Access Compliance Report

Public Rights-of-Way

(Curb Ramps)

Intersection ID: 21972	Main Street: ENGLAND_ST	Cross Street: PENINSULA_LN	Location: NW
ADA ID: 79D176BBFCD1	Ramp Type: PerpDiag	Initial Pass/Fail: Fail	Overall Compliance: No
		Severity Score: 12.5

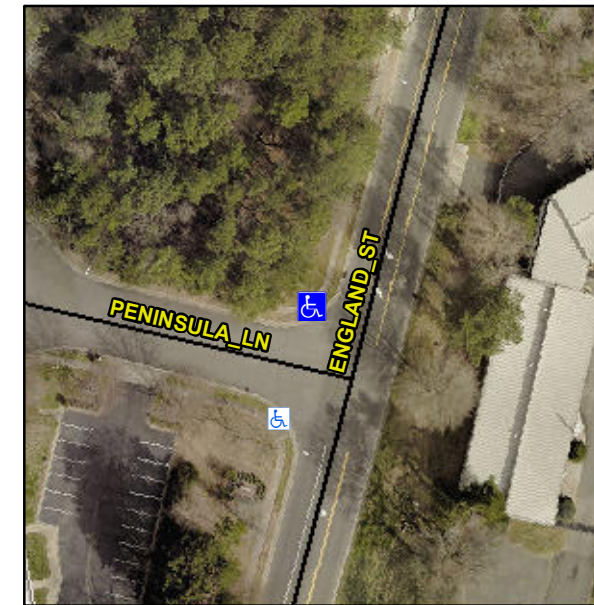
Not Found, R304.2.2

Compliance	Description	Data	Compliance	Description	Data
N/A	Ramp Length (in)	93.0	No	Ramp Slope (%)	8.5
Yes	Ramp Width (in)	48.0	Yes	Ramp XSlope (%)	0.8
N/A	Flare Type LT	N/A	N/A	Flare Type RT	N/A
N/A	Flare Slope LT (%)	N/A	N/A	Flare Slope RT (%)	N/A
N/A	Flare Traversable LT?	N/A	N/A	Flare Traversable RT?	N/A
N/A	Landing Length (in)	N/A	N/A	DWS Provided?	N/A
N/A	Landing Width (in)	N/A	N/A	DWS Contrast?	N/A
N/A	Landing Slope (%)	N/A	N/A	DWS Length (in)	N/A
N/A	Landing X Slope (%)	N/A	N/A	DWS Full Width?	N/A
N/A	Landing Curb? (Y/N)	N/A	N/A	DWS Offset (in)	N/A
N/A	Shared Landing?	N/A			
N/A	Gutter Ponding?	N/A	N/A	Gutter Slope (%)	N/A
N/A	Gutter Lip Ht (in)	N/A	N/A	Gutter X Slope (%)	N/A
N/A	Painted X Walk1?	No	N/A	Painted X Walk2?	No
	X Walk 1 Direction	To SW		X Walk 2 Direction	To SE
N/A	X Walk 1 Width (in)	N/A	N/A	X Walk 2 Width (in)	N/A
	X Walk 1 Slope (%)	1.3		X Walk 2 Slope (%)	2.5
	X Walk 1 X Slope (%)	3.3		X Walk 2 X Slope (%)	1.3

Remove & Replace Curb Ramp With Two New Directional Ramps or Equivalent.
